**DOCUMENT 00 90 00  
ADDENDUM**

**ADDENDUM NO. [4]                      Date: November 21, 2018**

**RE:                      GLENWOOD COMMUNITY SCHOOL DISTRICT  
ATHLETIC COMPLEX IMPROVEMENTS BID PACKAGE 2 REBID  
400 SIVERS ROAD  
GLENWOOD, IOWA 51534  
HSR PROJECT NO. 18005**

**FROM:                  HSR Associates, Inc  
100 Milwaukee Street  
La Crosse, WI 54603  
(608) 784-1830**

**P102R**

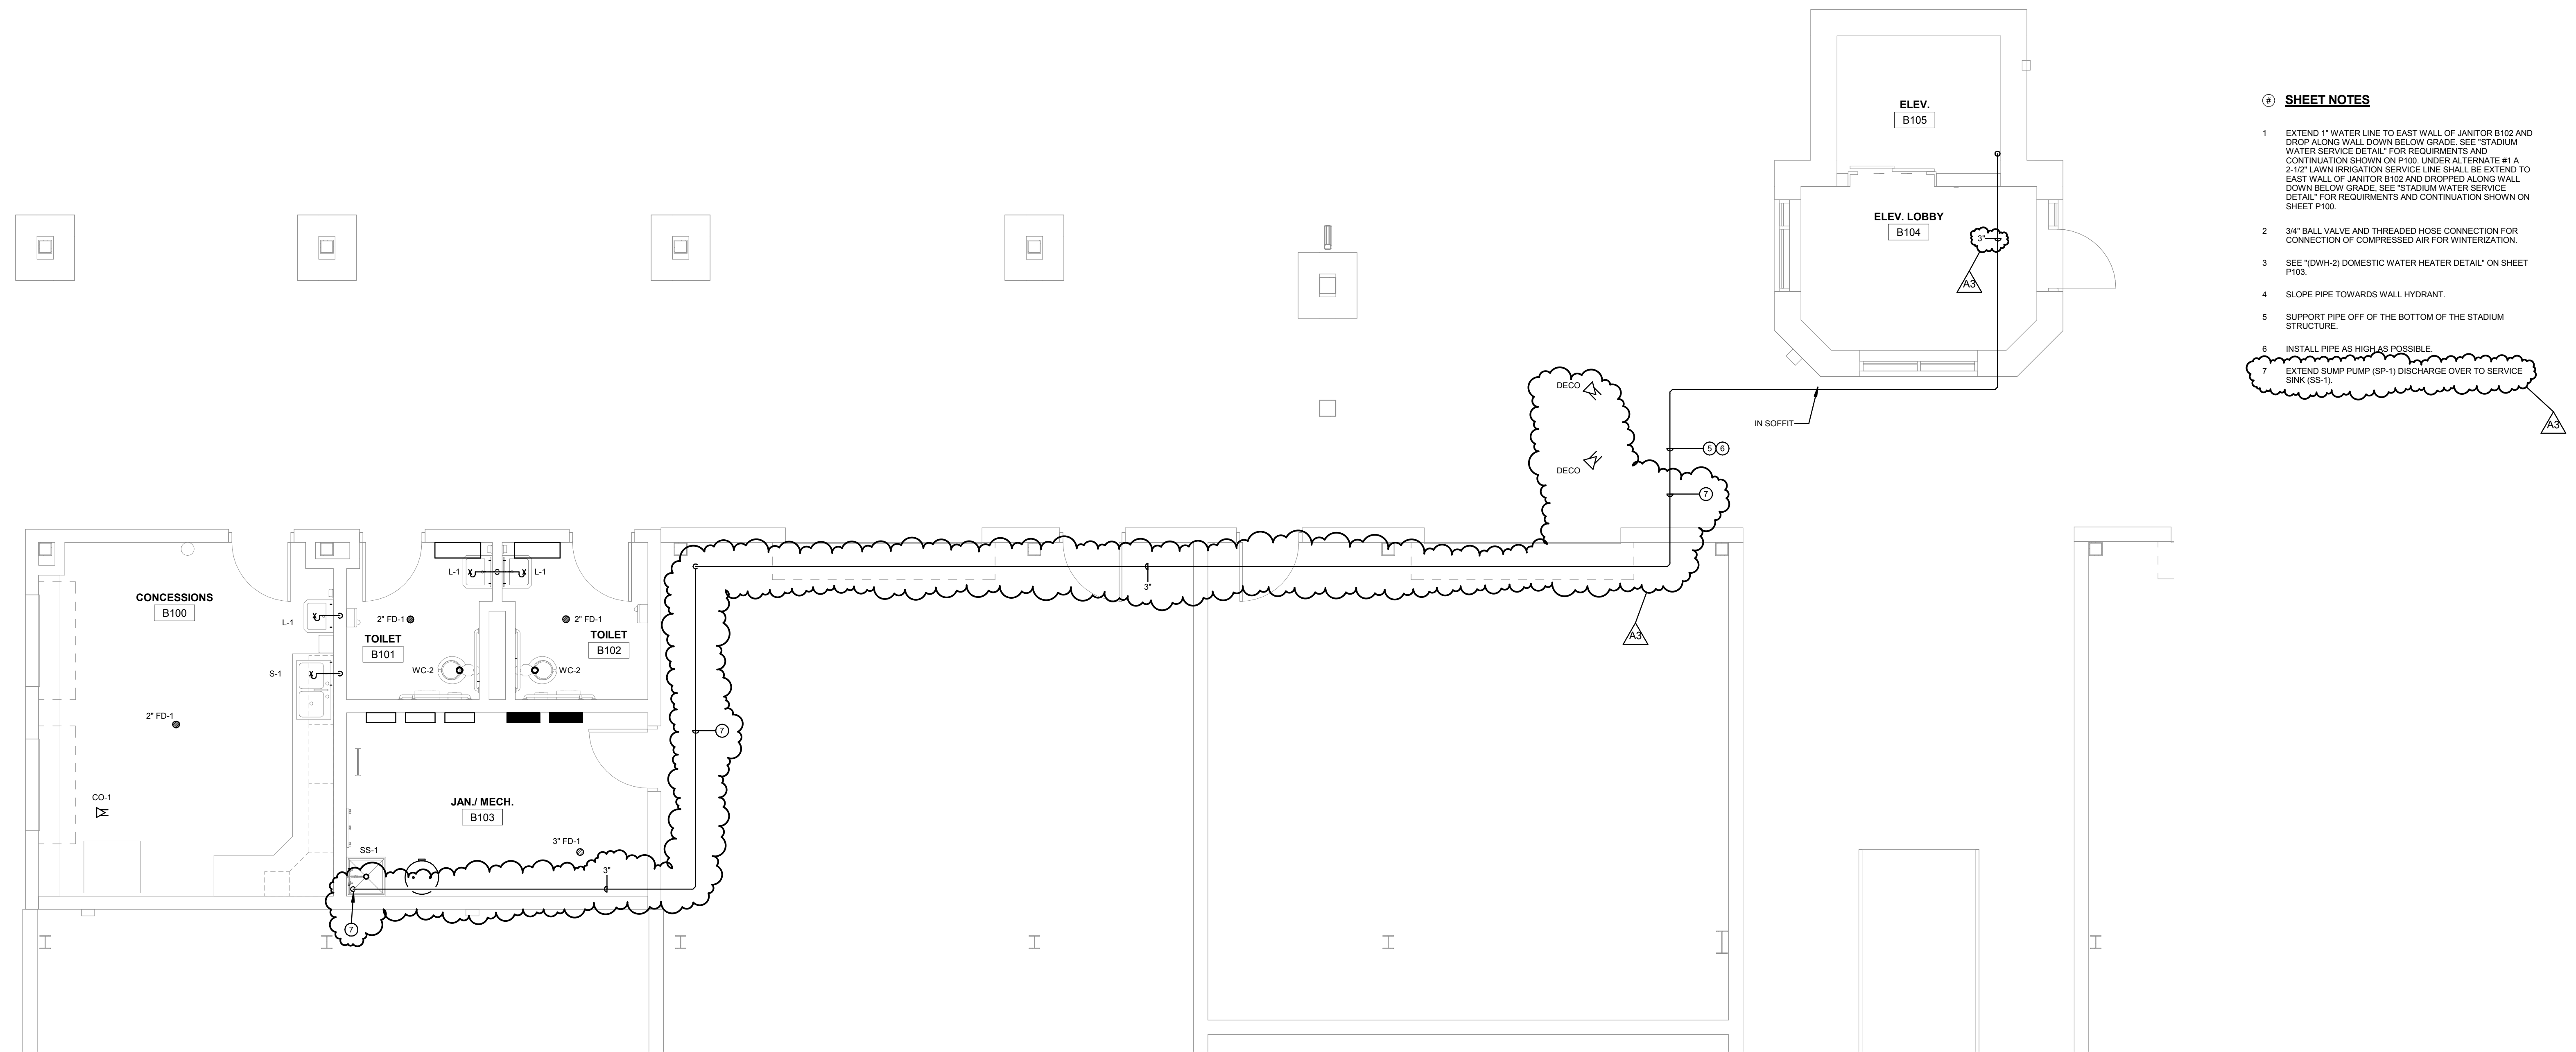
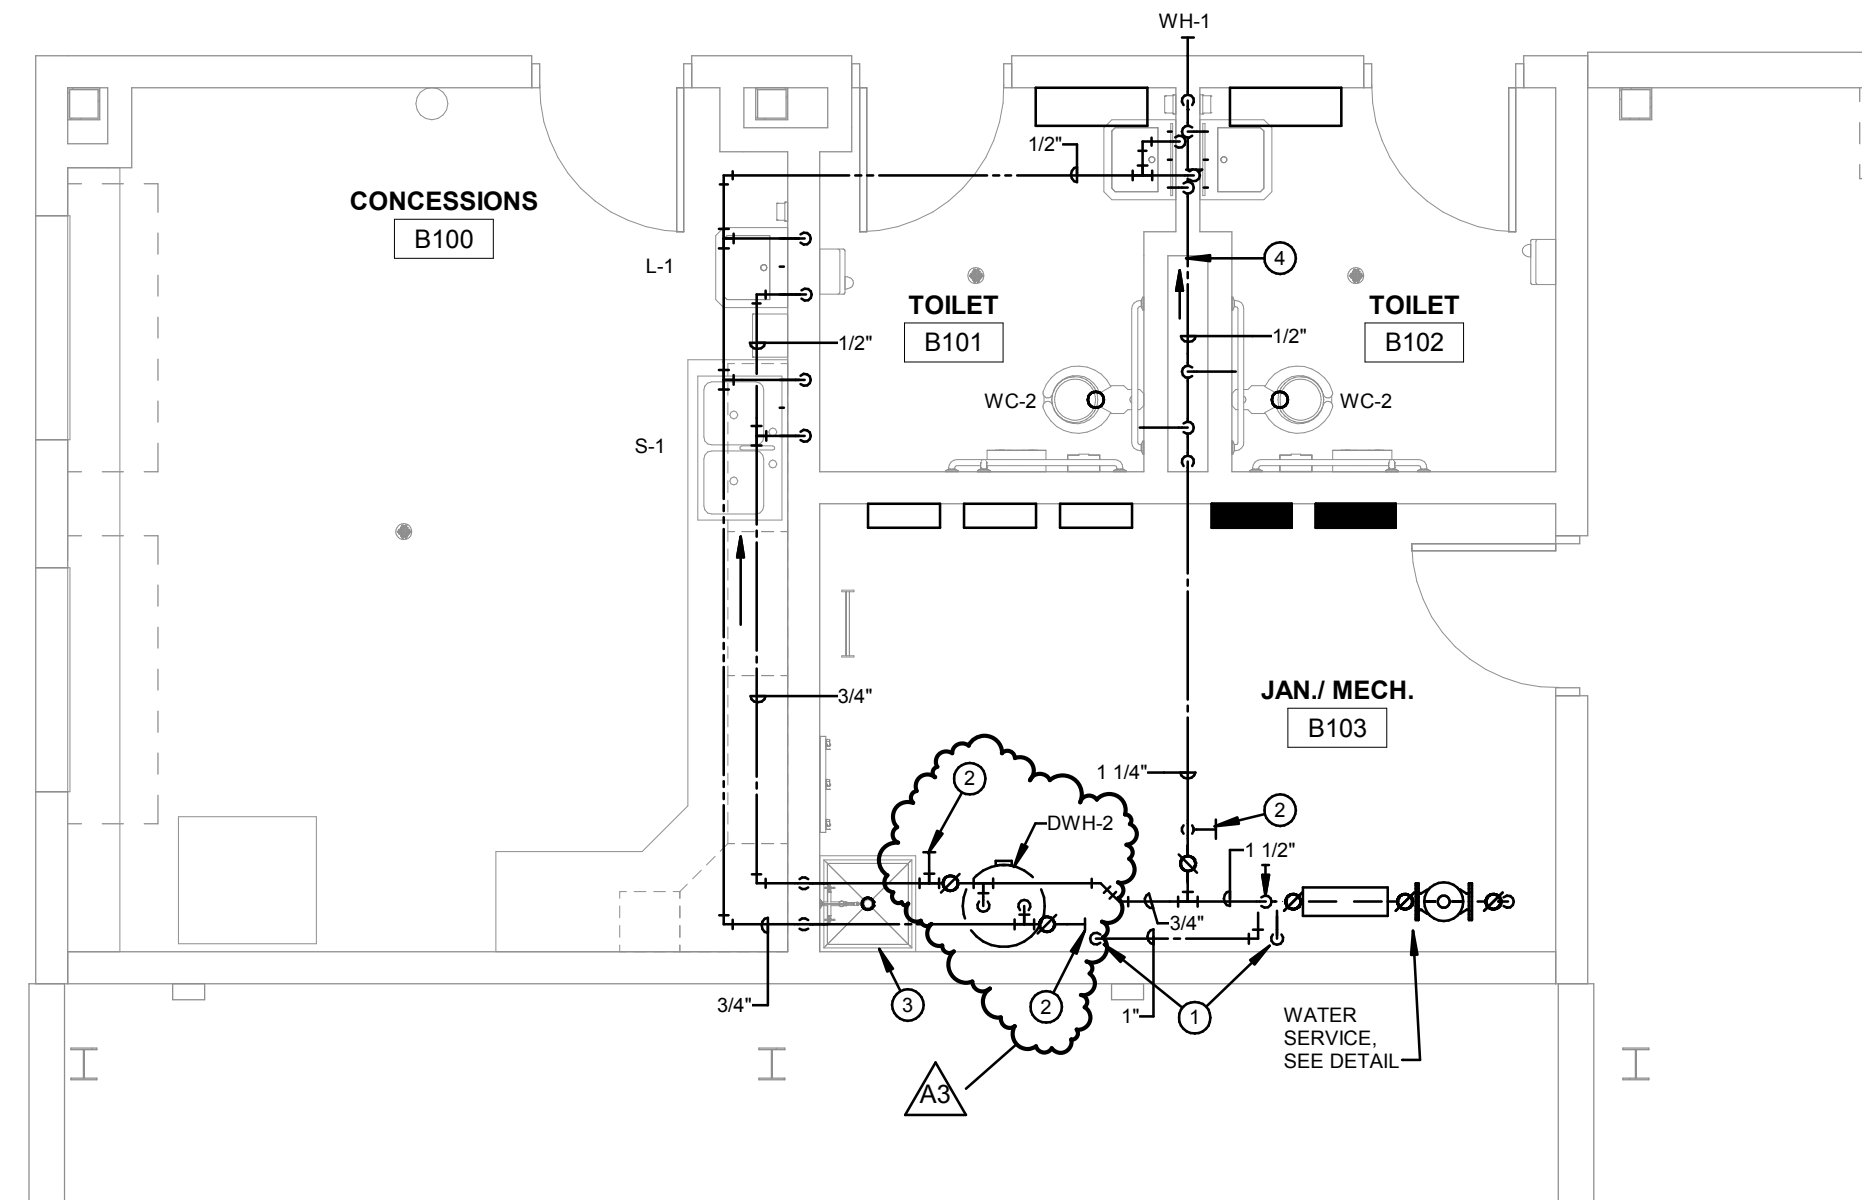
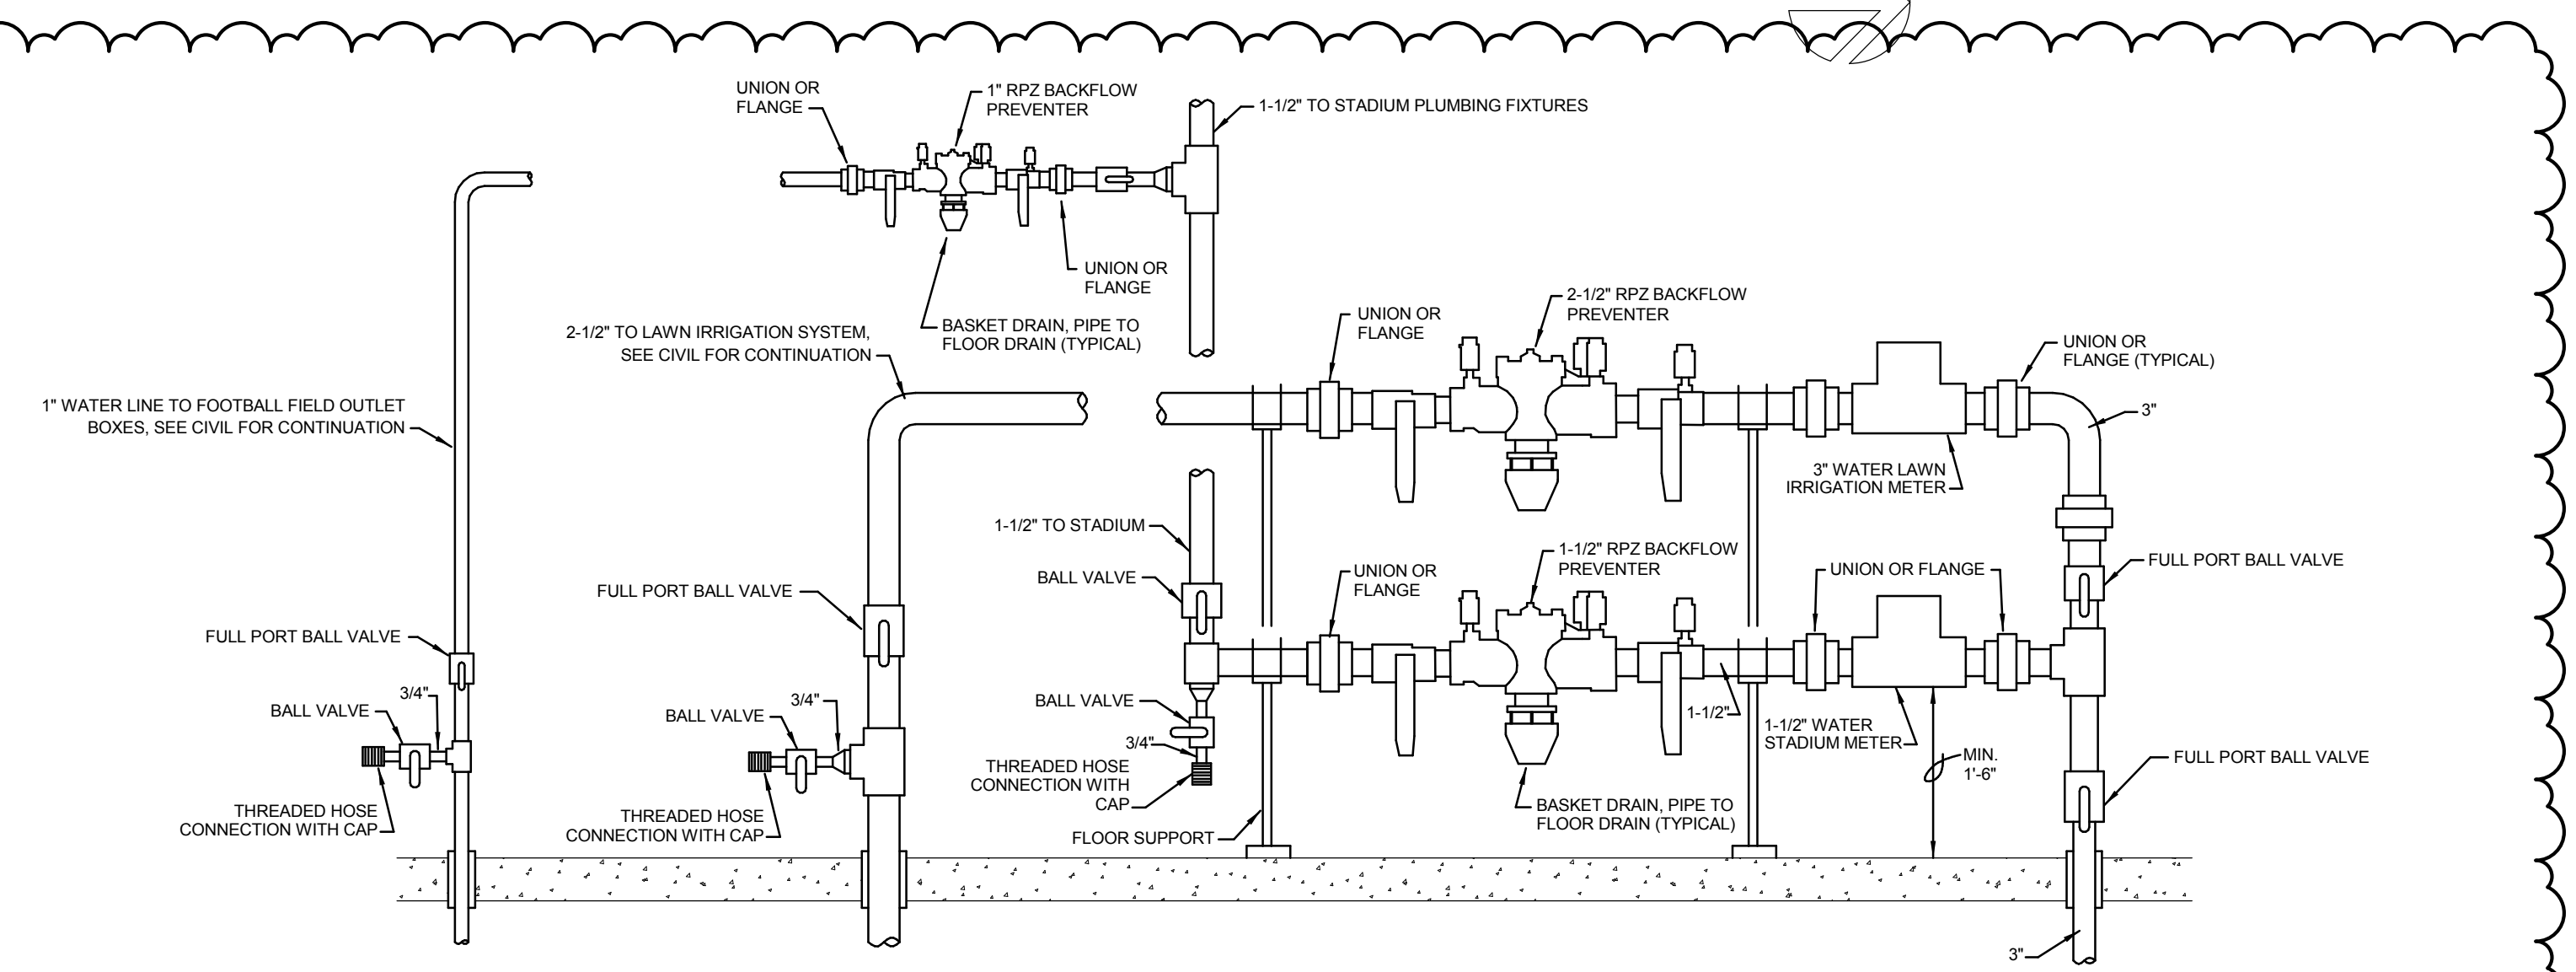
Sheet P102R STADIUM BUILDING PLUMBING PLAN 30 x 42 attached hereto.

- a. Revisions clouded on Drawing
  - b. Added elevator sump pump (SP-1) horizontal pipe discharge from 2" to 3" and extend to over to service sink (SS-1) in Jan. /Mech. B103.

- c. Locate domestic water heater (DWH-2) located on floor next to service sink.
  - d. Revised Stadium Water Service Detail – there are two details with (1) for Base Bid and (1) for Alternate Bid.

- e. Revised sheet note #7.
4. Sheet P103R PLUMBING SCHEDULES, DETAILS & SYMBOLS 30 x 42 attached hereto.
- a. Revisions clouded on Drawing
  - b. Update Elevator Pit Sump Pump Detail – Show 3" PVC horizontal pipe with 2" riser from sump pump (SP-1).
